Service Bulletin No. WR20050108A
Subject: Voltage Regulator/Charge unit
Model: BLW-400SS
Product Group: Welder / Generator
Date: March 28, 2005

Series/Parts Affected:
Voltage Regulator and charging unit Change

Machines Affected
BLW-400SS Welder Generators
All units below serial number 3728376

Figure 1

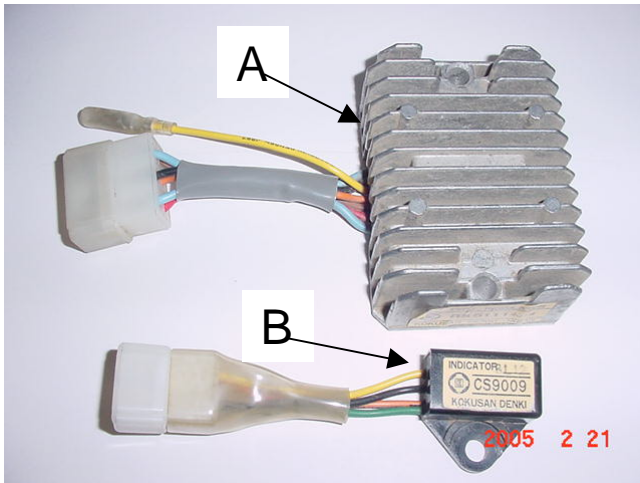
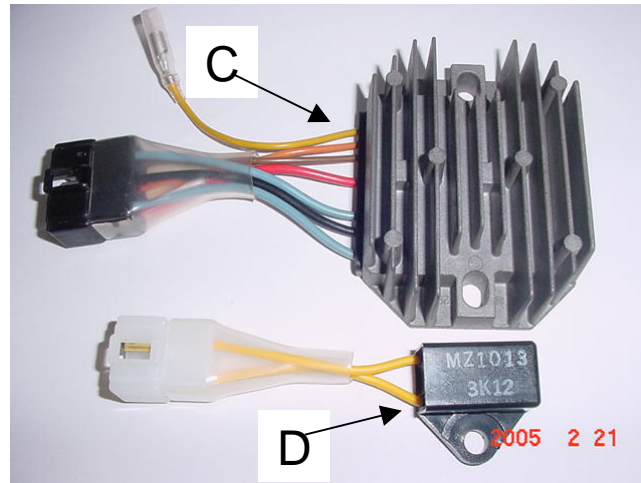
Problem
 We have received reports that some BLW-400SS machines below S/N 3728376 with Kubota Engine V-1205 may experience the charge light to stay on when the engine is started and will automatically shut down the engine within 10 to 15 seconds after replacing the Voltage regulator (Part No. 1518164602).

Solution
 Kubota has discontinued their old style voltage regulator P/N 1518164602 (**Figure 1A**) and replaced it with a new styled regulator (P/N1584464601), and charge indicator (P/N 1584460191 (**Figures 2C and 2D**)). When replacing the old regulator, use Regulator Service kit P/N 1518199201, this kit includes both the new regulator and new charge indicator.

1. Item **A** part number 1518164602 (Old Style Regulator) is no longer available and cannot be purchased.
2. Item **B** part number 151816091 (Old Style Charge Indicator) is available and can be purchased. This unit will only work with the older style regulators. **DO NOT** use this item with the new style regulator (**C**).
3. Item **C** part number 1584464601 (New Style Regulator) is available and can be purchased. This unit will only work with the new style Charge Indicator. **DO NOT** use this item with the old style charge indicator (**C**).
4. Item **D** part number 1584460191 (New Style Charge Indicator) is available and can be purchased. This unit will only work with the new style regulators. **DO NOT** use this item with the old style regulator (**C**).
5. If item **A** fails, replace with **New Regulator Service Kit** P/N 1518199201.
